HDC Information Request

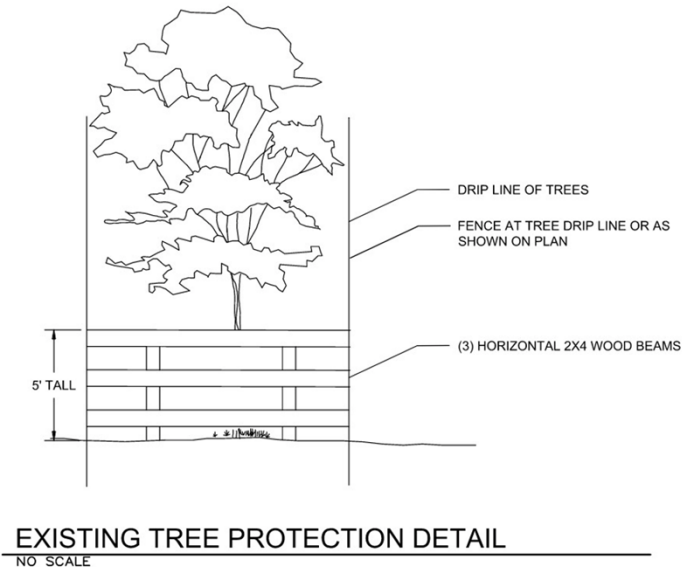
- I. Finer detail about existing landscaping around the excavation sites and the access routes to those excavation locations, including identification of all locations of vegetation.

Detroit Thermal has surveyed the site with their professional land surveyor, landscape architect and certified arborist. All plant material adjacent to the proposed excavations, along the access routes and at the layout down area have been located and memorialized on the provided plan set.

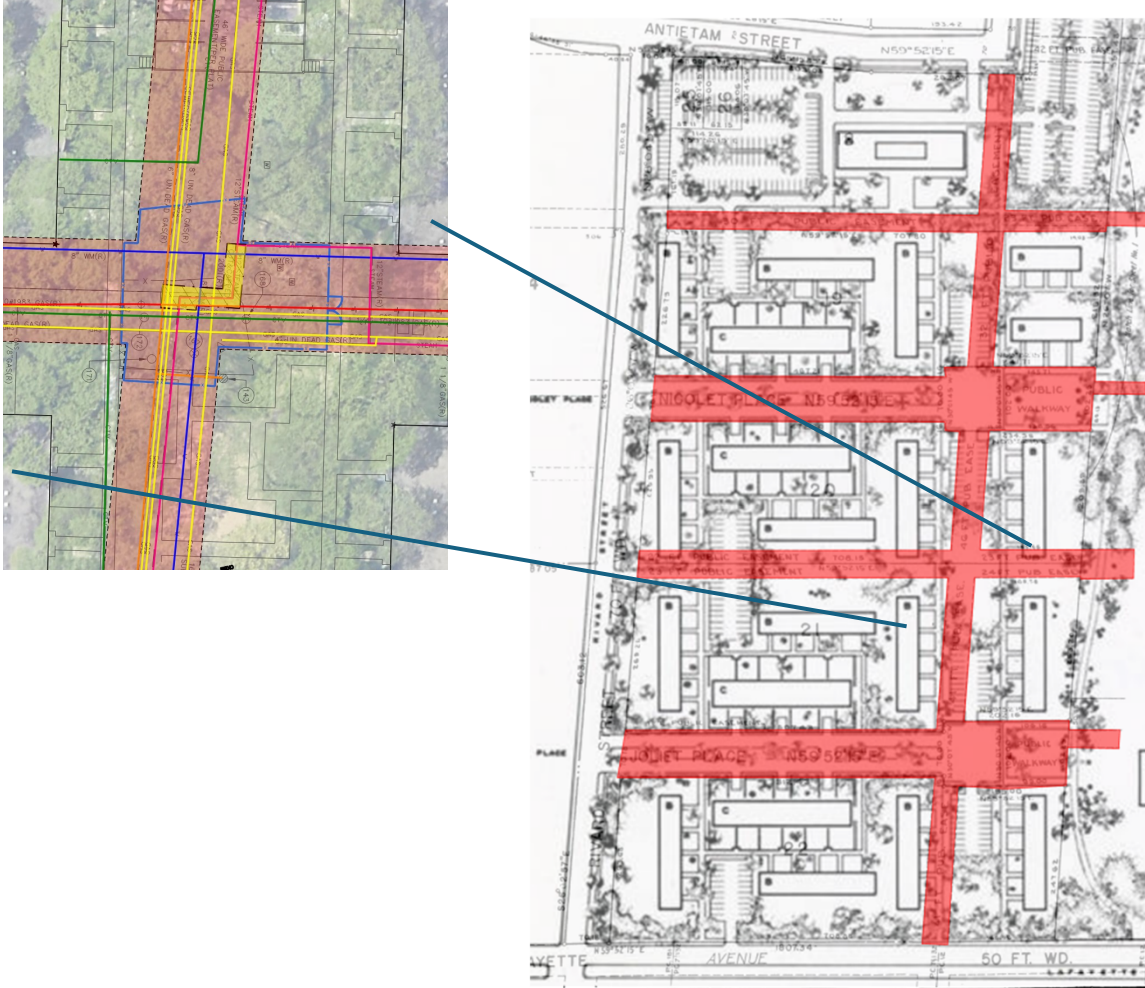
VII. Proposed equipment staging locations and approach.

- a. The area of the vacated Macomb and Russell Streets, north of the play area, will be accessed via the Lafayette Plaisance Park off Lafayette Ave., see callout 2.
- b. The area for staging, laydown and the stockpiling of material will also be in the park, see call out 1, and will be secured with a 6ft. tall construction fence, see callout 3.
